CITY OF NEWTON, MASSACHUSETTS

SUBJECT: #179-08 FB NEWTON PROPERTIES, LLC/FB NEWTON PROPERTIES c/o
PARAGON PROPERTIES petition for SPECIAL PERMIT/SITE PLAN
APPROVAL to demolish an existing retail/restaurant building and to construct a
new building for retail/restaurant building with a basement and rooftop parking at
215-277 NEEDHAM STREET, Ward 5, on land known as Sec 51, Blk 28, Lot
8G, containing approx 70,837 sf of land in a district zoned MIXED USE 1.

Zoning Review Memorandum

MEMORANDUM

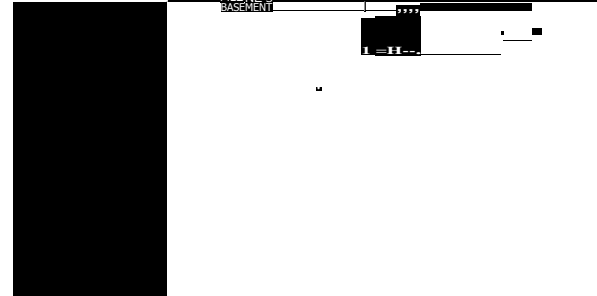
The petitioner proposes to install two independent freestanding signs. The first pole sign, is intended to replace the ground level parking sign approved under BO #610-89 and will advertise the presence of Filene's Basement and the two other retail spaces. A second freestanding sign is proposed to be located in the pedestrian plaza in the form of a decorative clock with Filene's Basement identification below. While two freestanding signs near the corner could be considered unnecessary, they are of different styles and functions and are visually separated so as not to clutter the sidewalks or compete with each other and the clock offers a traditional decorative element near the main entry. However, the sign with tenant identification would be just as effective if decreased in size and lowered so it is more at eye level.
